Questions and Responses: DOE Status Review 2025

Questions and Responses: DOE Status Review 2025.....	1
Pre-review Questions (9).....	1
CE Questions.....	1
General/L2 Managers (4).....	1
ECON/Silicon Motherboards (4).....	2
Cassettes (5).....	3
Review Questions (29).....	4
Outer Tracker (2):.....	4
Endcap Calorimeter (4+1).....	5
MIP Timing Detector (8).....	8
Project Controls (4).....	11
PM and ESH&Q (10).....	13

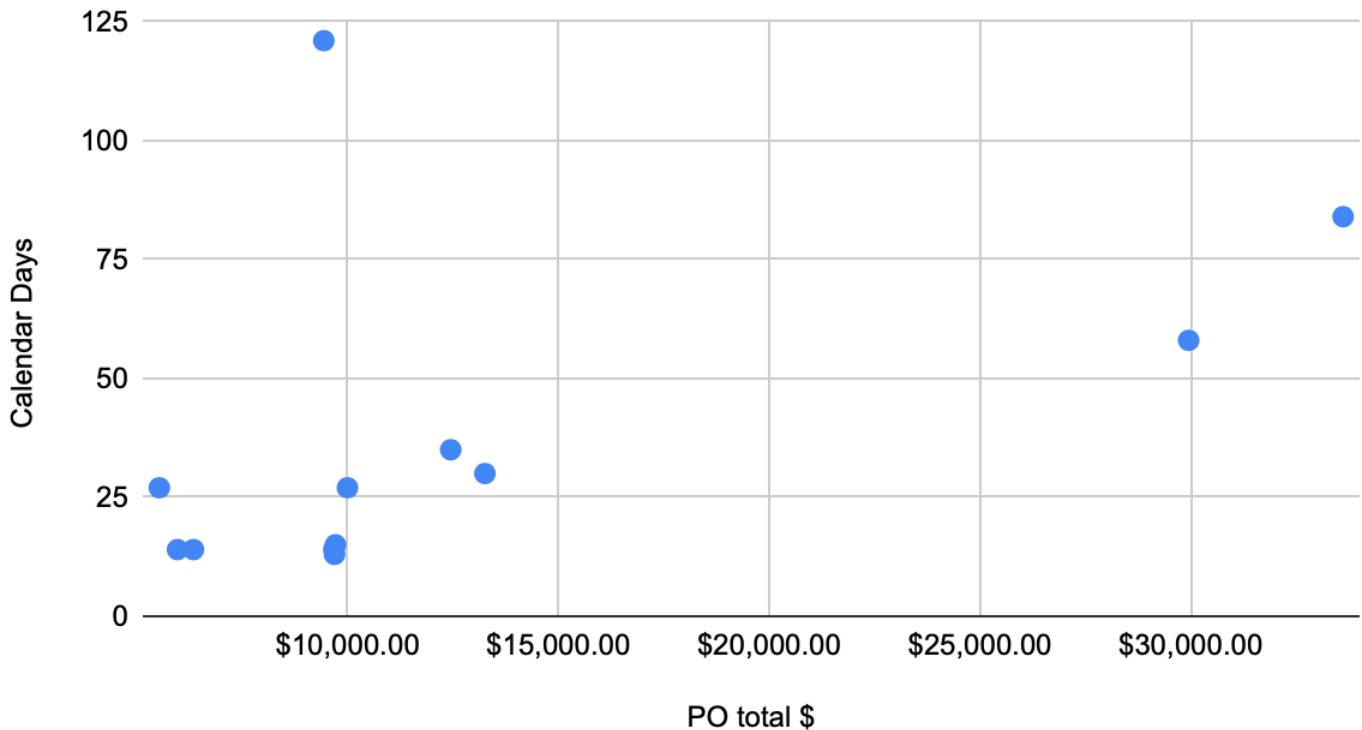
3. What has been your recent experience regarding turn-around on procurement with Fermilab? What is the average time it takes to get a PO out of the lab for the type of POs that are still outstanding?

Looking forward, we have some large expected procurements (e.g. cassette machining) and many smaller procurements (PCB procurement and/or assembly for varieties of tileboards, cassette hardware, etc). Our experience with the large cooling plate procurement was a total duration of 78 days, which matches the expectation. For the smaller procurements, our experience is shown below and typically requires between one and three months.

The table below shows HGCAL purchases for this FY25 made through procurement (not e-marketplace) above about \$5,000 originated by P. Gandhi, H. Gutti, Z. Gecse, H. Cheung. The chart below shows the calendar days vs PO value for the time from PR submission to PO approval. The long time for PR # 362938 was due to incorrect PF18 form and questions from the buyer and changes to the PR that needed several PO resubmissions, procurement was also on hold ~12/20/2024 -2/1/2025 due to the transition.

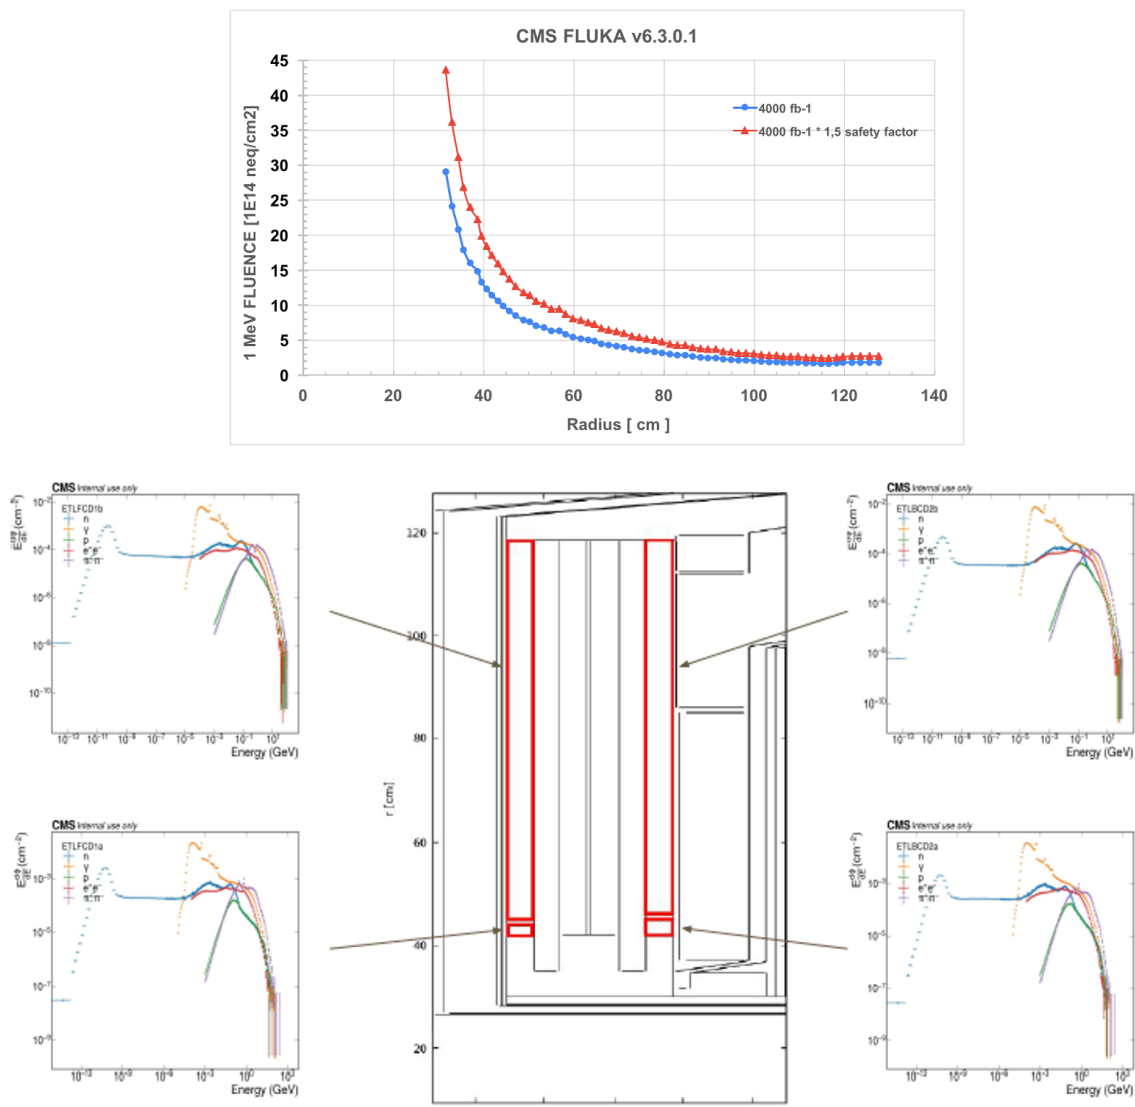
- From Project Management Addendum to Question 9 regarding schedule pressure vs performance: Can you address whether a system test of some reasonable scale is being planned for the CE? If so, what is the scale of the planned test and when is it nominally expected to occur? If such a test is not under consideration, please explain the reasoning for omitting it.

Given the modular nature of the CE, many crucial aspects are validated with the existing system tests, which consist of 2 LD trains + 2 HD trains and a 10-degree scintillator section which includes all aspects of a full cassette. Indeed, previous versions of these tests have identified an issue with the I2C of the HGCROCV3b

which would have had a significant negative impact on operations and possibly performance, as well as some bugs in board layouts. In the current system tests, the issues identified have been in the backend firmware and software, which must evolve to handle larger and more-complex systems. This is very useful work, but does not affect the readiness for construction. We are continuing to scale up the testing, with full-cassette tests under preparation to be carried out in June and July.

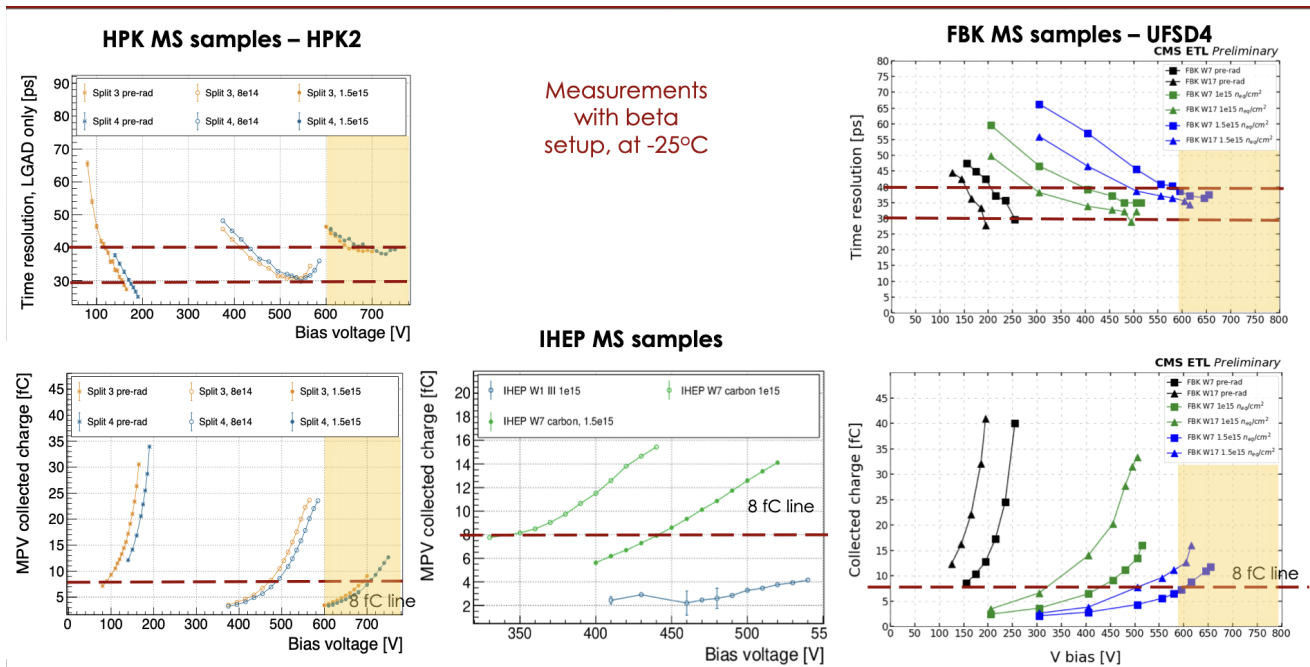
- b. Are there any measurable effects of TID on the performance of the system - ie on time resolution etc?

We have tested extensively the ETROC2 time resolution after TID through charge injection up to 400 MRad (the design specification is 100MRad), with no performance degradation observed.

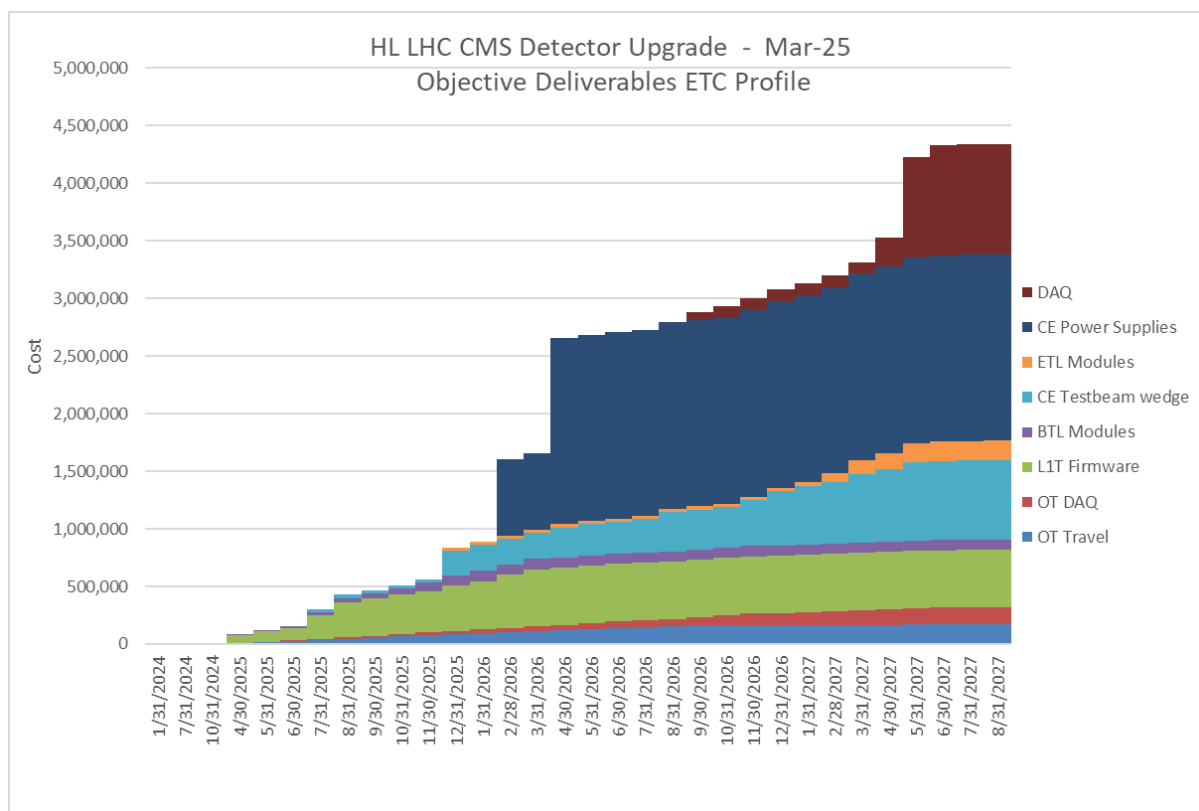
2. Cost and schedule contingency is a concern. What is the time frame for making a decision about delivering the threshold KPPs vs. Objective KPPs? Please provide these decision points by L2.

The ETC as a function of date for the Objective scope from the current RLS is shown here:

Some of the incremental items are starting now, while the larger contributions don't start until the end of the year, and the DAQ procurement is not until 2027. In addition, some of this can be offset due to current delays - i.e. the L1T delay implies that the Objective scope does not need to start as early.

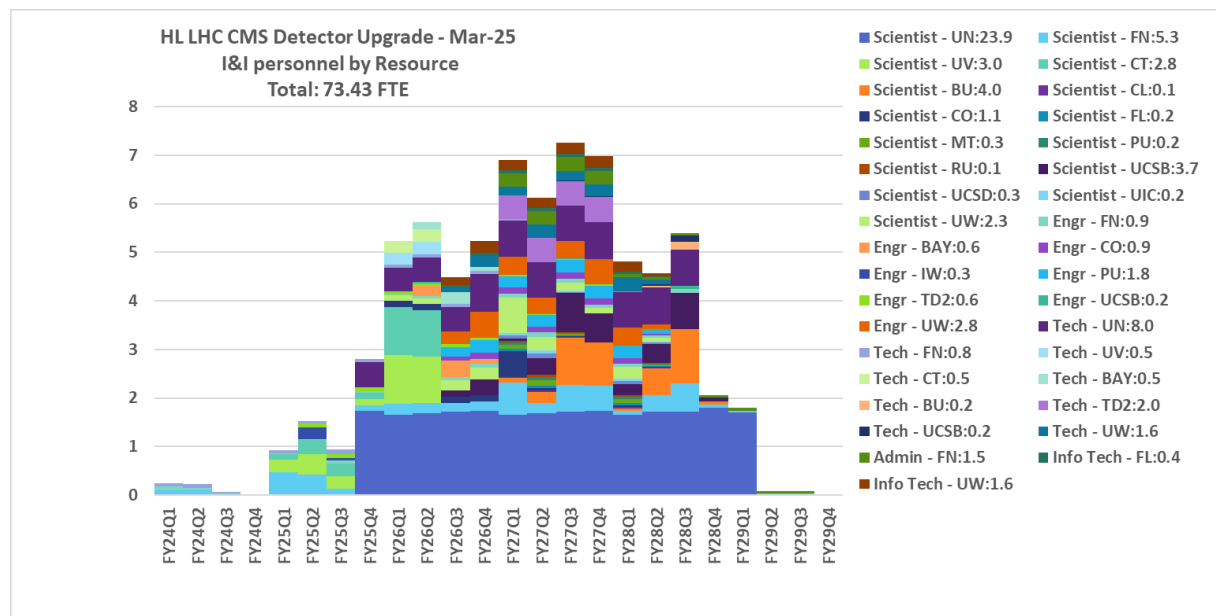
3. How far into production (in months and % complete) can the project go before funds must start being expended on objective KPP scope? Similarly, assuming you have to draw down on I&I to remain solvent, at what point will these reductions prompt a re-consideration your plan?

This is a similar question to C&S 1 and 4. For the objective scope, the timing depends on the scope in question, but of the 4.3M we expect to have spent about 500k by the end of this FY, and another 2M by this time next year, dominated by the Power Supply procurement. This sets the scale for the earliest date as the procurement of the power supplies should start about 6 months ahead of when the payment is actually made. From then, there is gradual increase on the “incremental” objectives, and then the DAQ procurement which would need to be settled in FY27Q1.

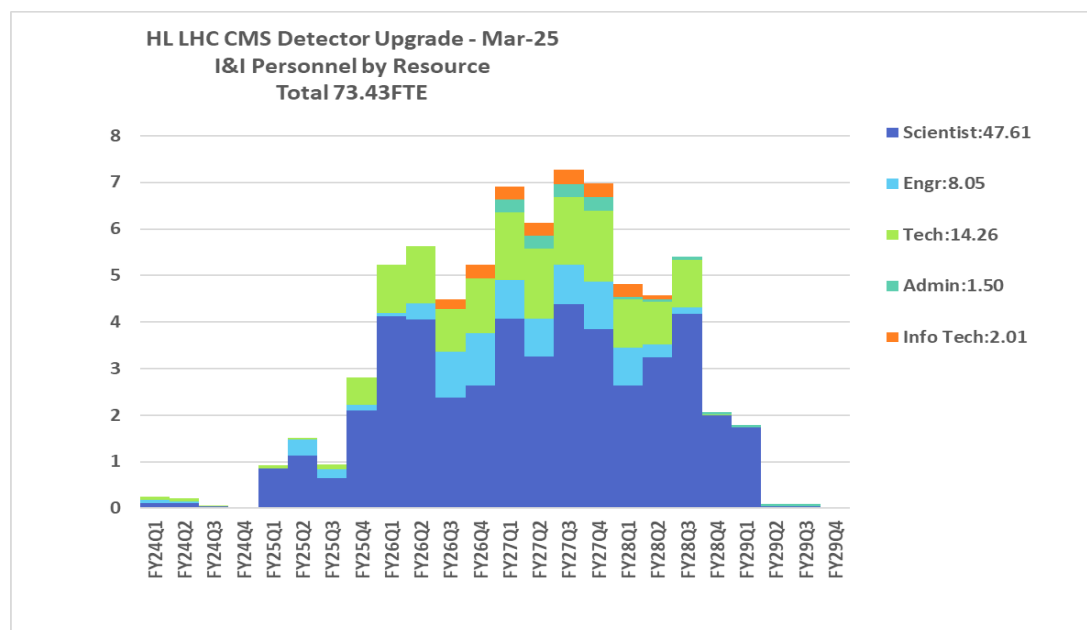
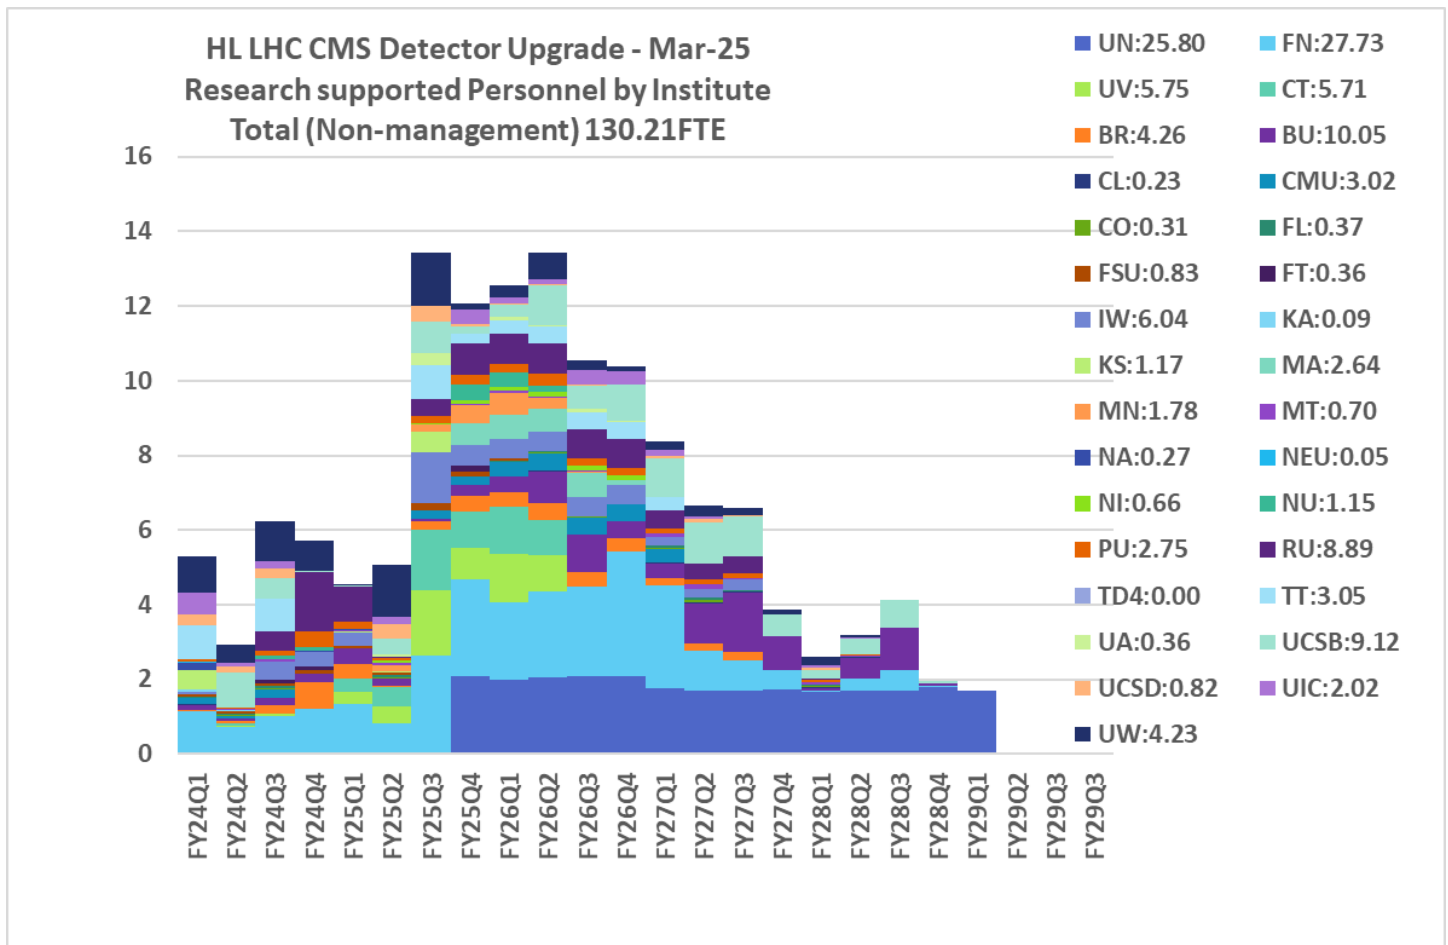
5. Please provide the anticipated FTE labor profile by ~ quarter for I&I personnel, by labor type and institution, if available.

There are a lot of Institutes, which makes this plot difficult to parse, so we remove the Institutes below

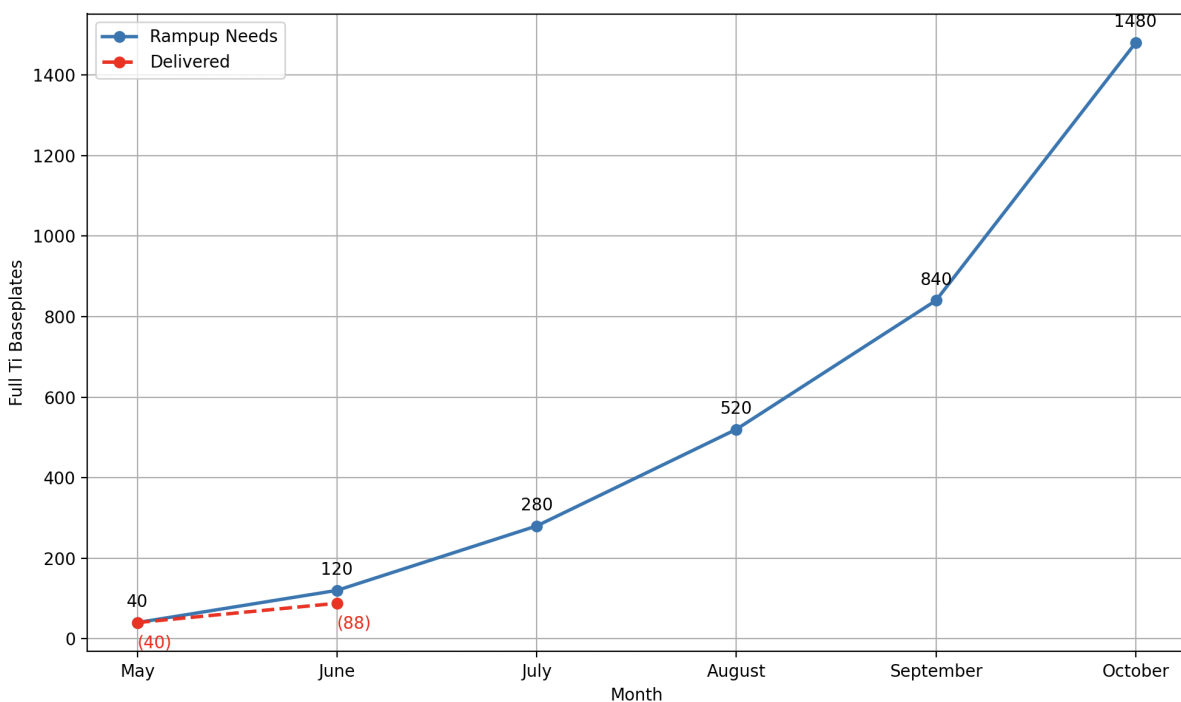
7. Please speak to the project's exposure, including areas of most concern to project management, to the timely receipt of components from international collaborators needed for US construction. Please fold in your estimates of the anticipated rate of ramp up from this point in time forward, as well as increases to date.

OT - hybrids; CERN is working closely with the vendor (Valtronic) and they devised a delivery plan, initially monthly, and later quarterly. This plan shows the ramp up. It can be seen in this table (green=delivered, black=planned, one line per hybrid type). Note "Uncertain performance of Hybrid Vendor" is the highest Schedule risk in terms of P*Impact that the project has, by a factor of 2. (Taylor talk, slide 8)
